SUBJECT: REQUEST FOR AN AMENDMENT TO LICENSE NUMBER 21-01354-03 DATED MARCH 23, 1984
AND OUR REQUEST FOR ADDITIONAL INFORMATION DATED DECEMBER 6, 1984
AND FOLLOW UP PHONE CONTACT ON JANUARY 7, 1985

This is in reference to a report dated April 13, 1984, signed by Joseph P. Ohlmacher, describing the results of a radiation survey of your cobalt-60 teletherapy unit. In order to complete our evaluation of the report, we need the following additional information:

Radiation Safety Survey
April 13, 1984

Figure F-1 TELETHERAPY HEAD SURVEY

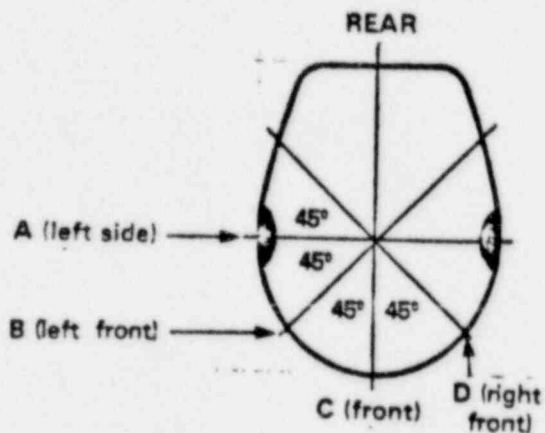
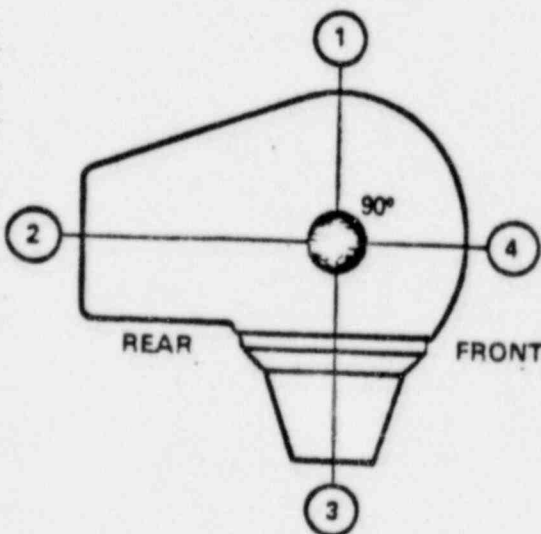
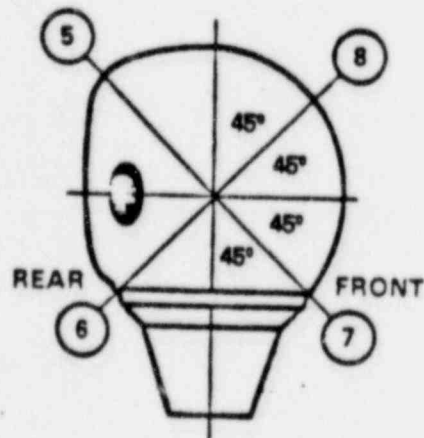
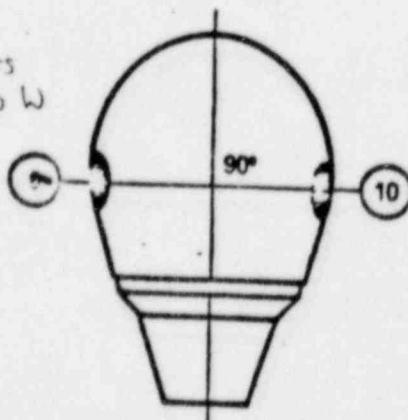
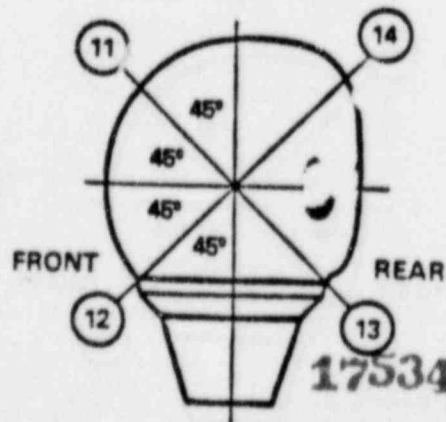
5. Specify the mechanical and/or electrical beam stops that are operational and restrict beam orientation when the primary beam is directed away from the integral beam absorber. Specify each direction in which the teletherapy head can be moved and the maximum angle (from vertical) of beam orientation in each direction.

5. Electrical interlocks prohibit a Beam-On condition when the central axis of the beam is greater than 1 degree laterally and/or 5 degrees longitudinally. Further, interlocks restrict beam size and rotation combinations which would cause the beam to not be intercepted by the beam stop. All interlocks are functional.
